# OVER THE SOLDERING IRON

RCA VICTOR

SERVICE DIVISION - RCA MANUFACTURING COMPANY, INC. - CAMDEN, N. J. - FEBRUARY 24, 1938

## Hum and Instability - Models 94X, 94X1, and 94X2

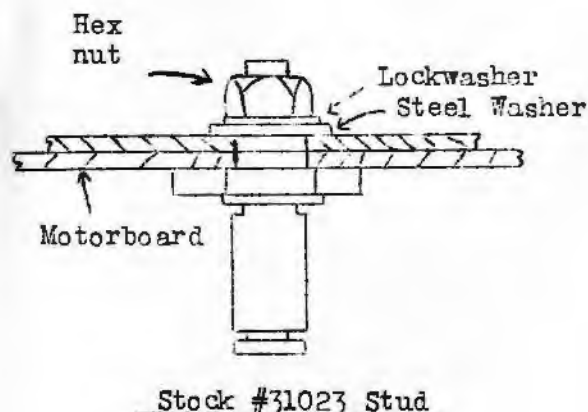
Residual hum level evidenced on some of these instruments, both on and between carriers, may be reduced to an insignificant intensity by making the following circuit changes: -

- (1) Cut off the blue lead from the dry electrolytic capacitor and disconnect it from the 6J7 cathode terminal.
- (2) Install a 0.25 mfd. paper capacitor, Stock #30965 from the 6J7 cathode terminal to chassis ground.
- (3) Try reversing speaker voice coil leads and leave them connected in the arrangement giving minimum hum.

Should there be a tendency for the receiver to oscillate only when tuned to a station, the lead from the 25L6G plate to the output transformer should be carefully dressed away from the 6J7 socket, preferably along the rear side of the chassis. The following circuit changes should be effected when aggravated cases of instability are experienced: -

- (1) 94X-94X1-94X2 -- Change 25L6-G plate by-pass capacitor C-11 (marked 72050-569) so as to connect from the 25L6-G plate to 25L6-G heater (H) lug adjacent to cathode (K).
- (2) 94X only -- Change 6J7 screen by-pass capacitor C-8 (marked 72050-503) so as to connect between 6J7 screen (SG) and the 6J7 heater (H) lug adjacent to cathode (K).
